**City of Pembroke Pines Fire Rescue**  
**Fire Prevention Bureau**  
 601 City Center Way 3rd FL  
 Pembroke Pines, FL 33025  
 PH (954) 499-9560

**FIRE SAFETY INSPECTION REPORT**

<b>Occupant Name:</b>	Heron Pond	<b>Inspection Date:</b>	1/19/2023
<b>Address:</b>	241 Southwest 84 Avenue	<b>Inspected By:</b>	Victor Santos
<b>Suite:</b>	Bldg. - #18	<b>Property Use Type:</b>	Multifamily dwelling
<b>Occupant Number:</b>		<b>InspectionType:</b>	Annual Fire Alarm (FAS), Annual Fire and Life Safety Inspection
<b>Occ. Sq. Ft.:</b>	20000	<b>Number of AEDs:</b>	0

1.1 - 10.1.4.1.

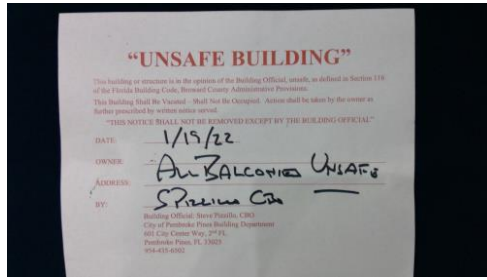
<b>Deficiency</b>		FL NFPA 01 2018 Chapter 10 General Safety Requirements	10.1.4.1 - Excerpt: Where structural elements have visible damage, the AHJ shall... (see photo 1.1)
-------------------	--	---	---

**Inspector Comments:** \*\*\*The noted structural damages have been referred to the City's Building Official and Structural Chief for evaluation of possible unsafe conditions. A site visit with structural inspectors and the Building Official to demonstrate areas of concern was conducted. Following the site visit, an structural engineer was consulted and in conjunction with the Building Official, deemed each patio/balcony area unsafe. The Building Official instructed Xochitl Alvarez, the property manager, to produce an analysis and proposal completed by a structural engineer for conditions and repairs within 48 hours. Each building and unit had an "Unsafe Building" notice posted on the front door as well as verbally communicated with residents who were home at the time. Residents were instructed that due to the unsafe conditions, they are to remain clear of the patio/balcony area until further notice is given.\*\*\*

Where structural elements have visible damage, the AHJ shall be permitted to require a technical analysis prepared in accordance with Section 1.15 to determine if repairs are necessary to restore structural integrity.
